AGENDA
President and Board of Trustees
Village of Arlington Heights
Board Room
Arlington Heights Village Hall
33 S. Arlington Heights Road
Arlington Heights, IL 60005
September 8, 2021
7:30 PM

A. Ridgeline/Rohrman Development - 1100 & 1400 W. Dundee Rd. & 1510-1530 W. Dundee Rd. - PC#21-009
PUD Amendment, Plat of Subdivision, Comp Plan Amendment, Rezoning Lot 1 from B-3 to M-1 and Lots 2 and 3 from M-1 to B-3

SHEET C-3 OF C-28

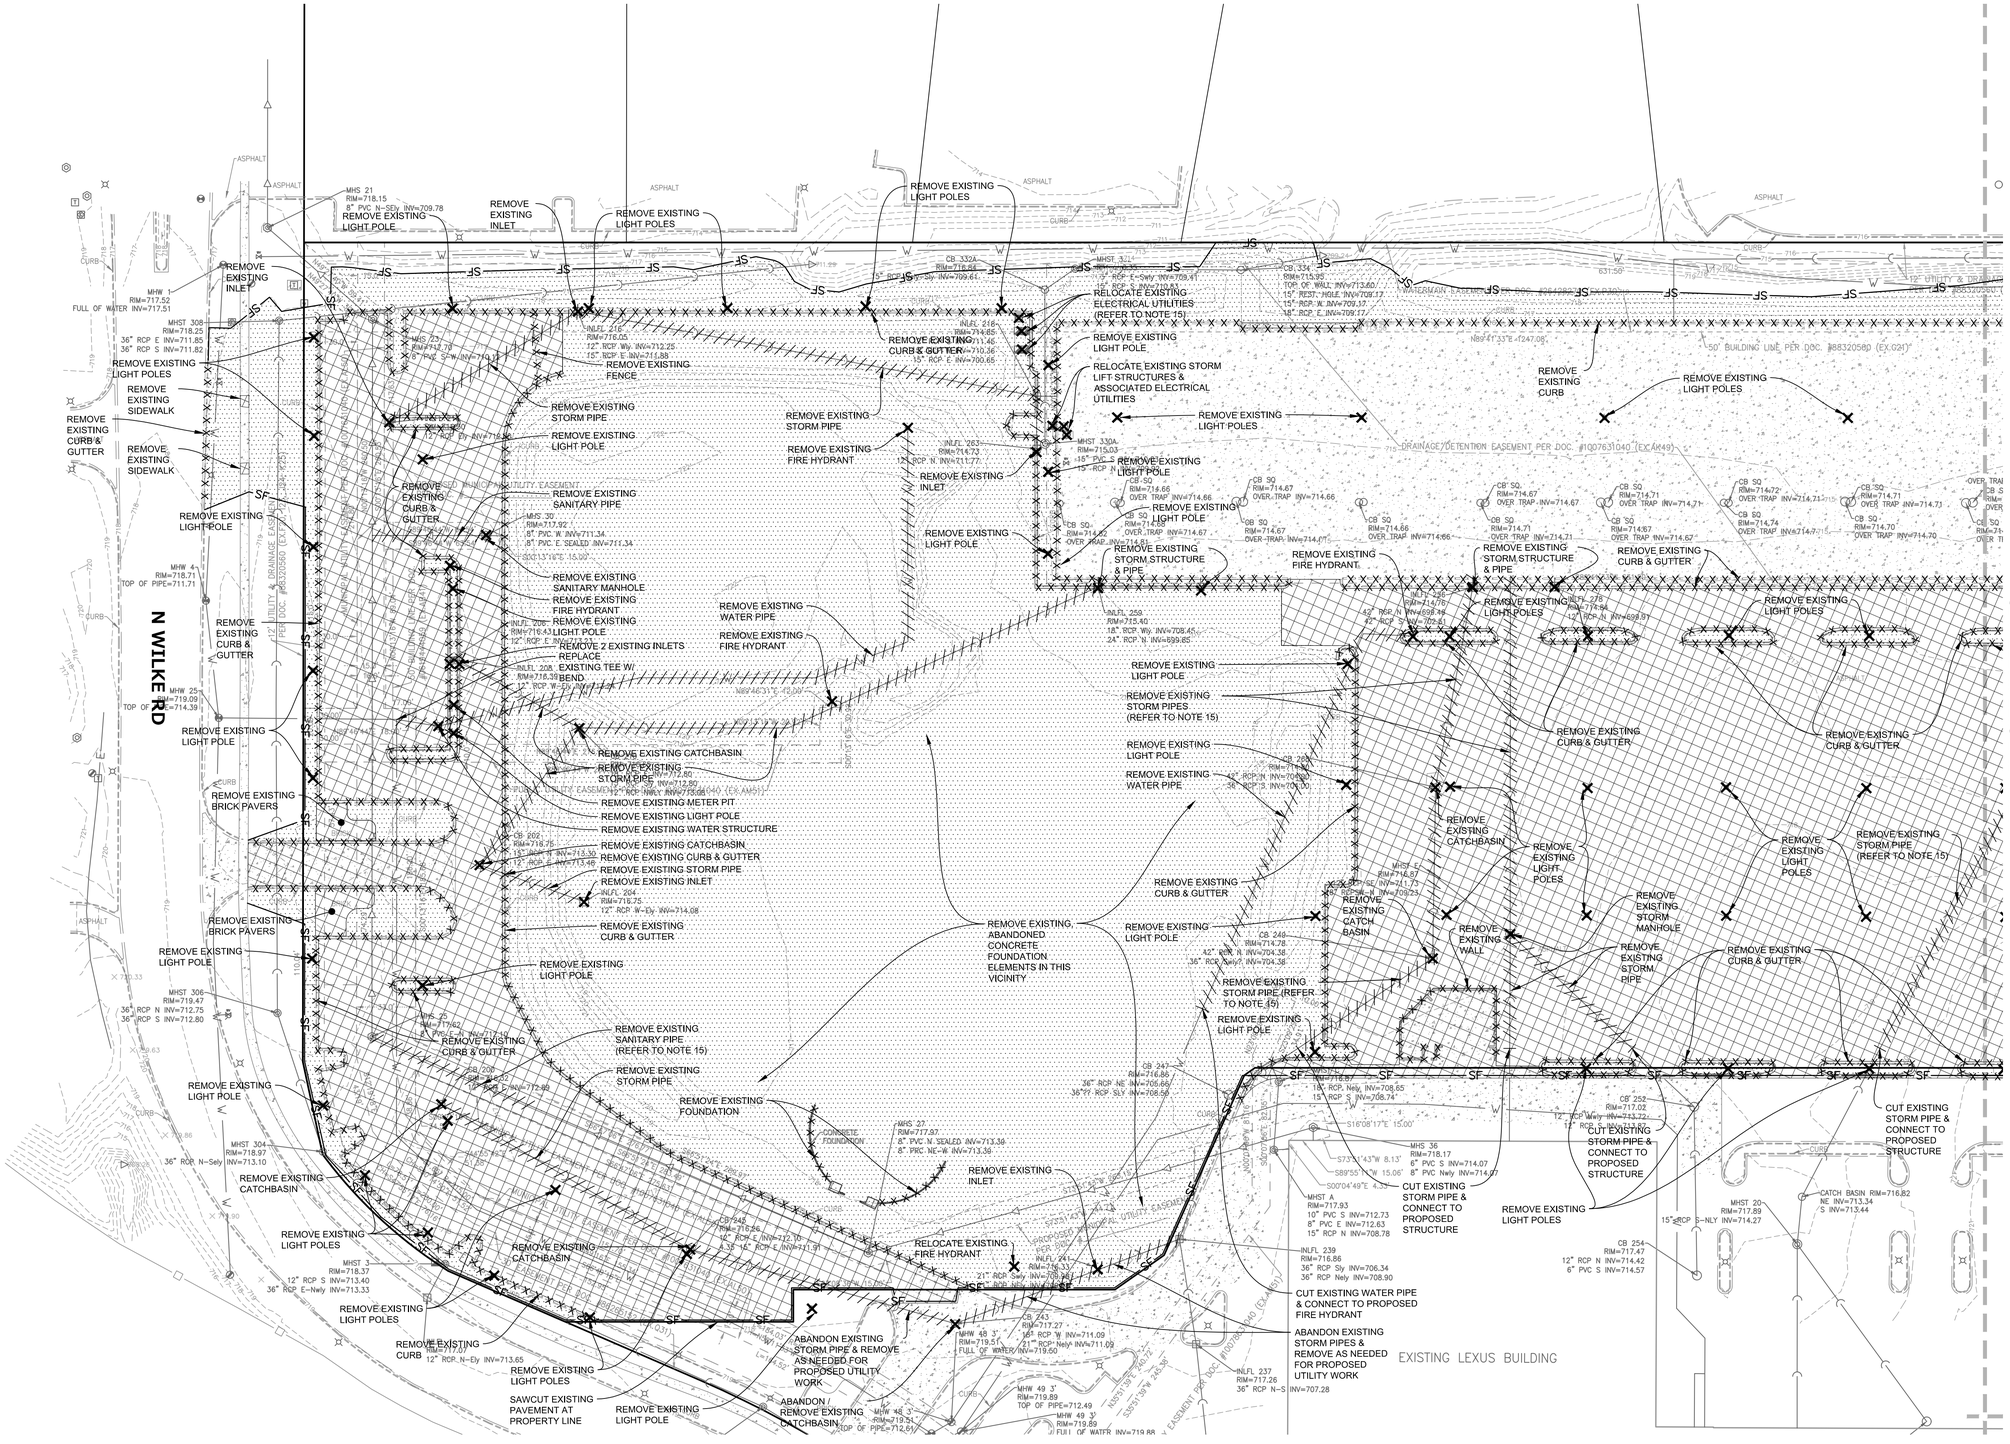
48. Add the following note to the Demolition Notes on Sheet C-3 and to the Utility Notes on Sheet C-15: "Coordinate all water main shut downs with Village Staff at least forty-eight hours (48-hrs) in advance."

48. The Add the following note to the Demolition Notes on Sheet C-3 and to the Utility Notes on Sheet C-15: "Coordinate all water main shut downs with Village Staff at least fourth-eight hours (48-hrs) in advance."
Response: We have added the note to all demolition sheets (demolition note number 16) and utility sheets (utility note number 15).

SHEET C-8 OF C-28

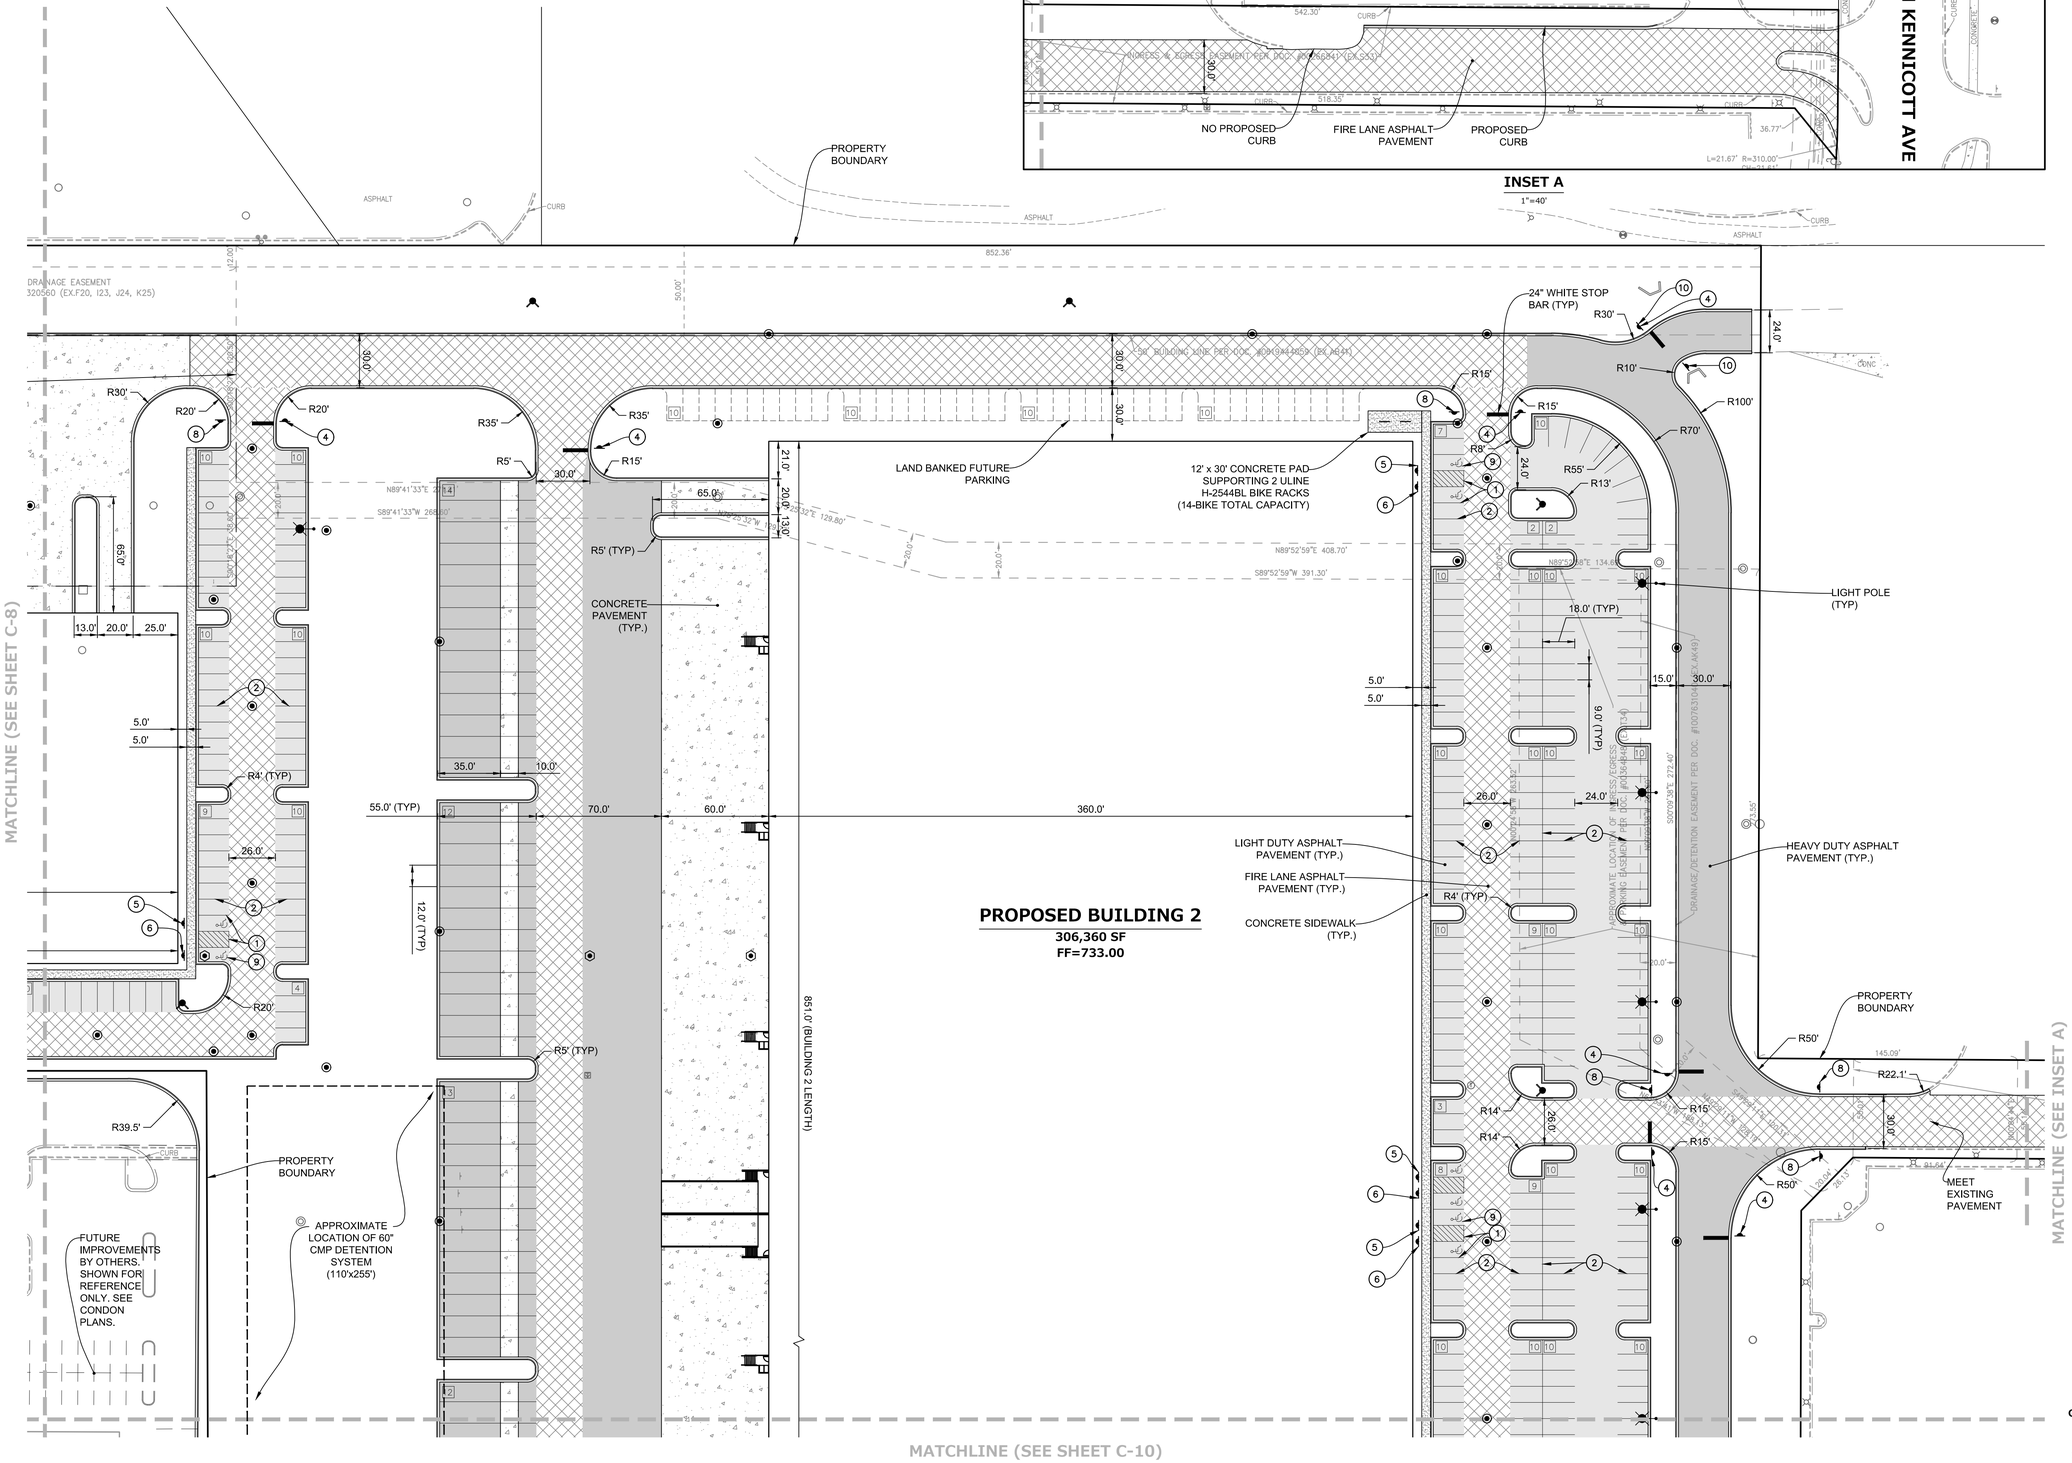
39. Sheet C-8 Shows entrance changes near Building #1, will be improved "by others". This area does not function well as proposed and needs to be corrected during construction. Please revise.

23) Per KLOA study, northbound truck egress from the northern truck access drive onto Wilke should be prohibited. Please add a note to sheet C-8 outlining signage for this restriction.

SHEET NUMBER: C2.0

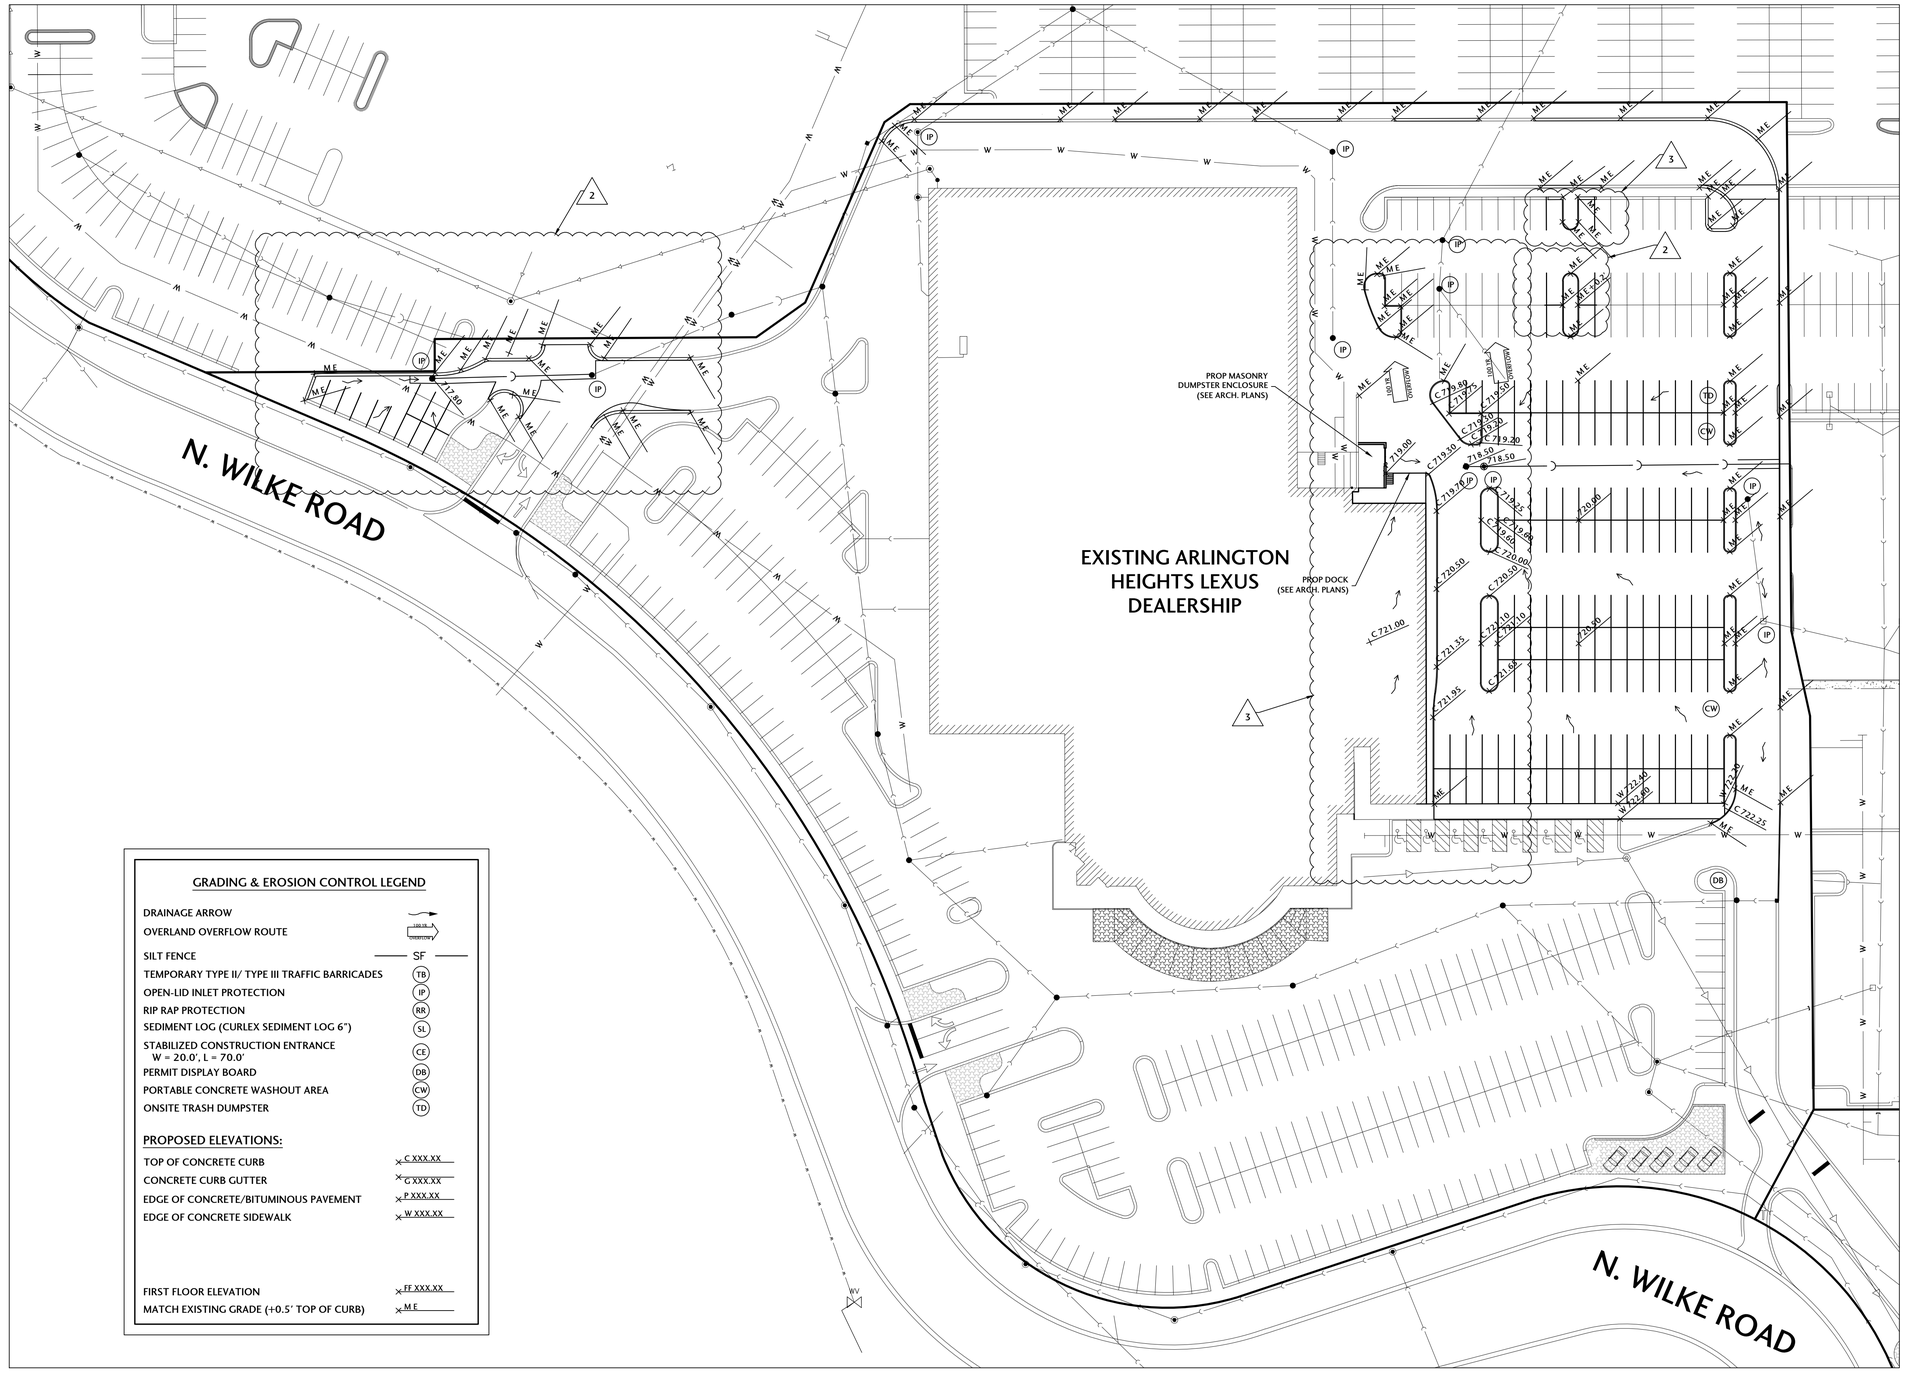
75) The response to comment #54 is not acceptable. As outlined in the comment #54 and as discussed during the meeting on July 2nd, the info provided within the table on sheet C2.0 is not sufficient and lacks the detail necessary to calculate the parking for the Lexus Dealership upon demolition Honeywell building. Please provide the highlighted information as outlined in comment #54. Please be sure the format and information is as shown in the table in #54.

Response by Lexus project team representative: Parking stall information has been added to sheet C2.0. The originally proposed number of handicapped parking stalls remains the same and thus meets Village code and previous approvals.

Response by Lexus project team representative: This information has been included on sheet C2.0 of the JCA site engineering plans.
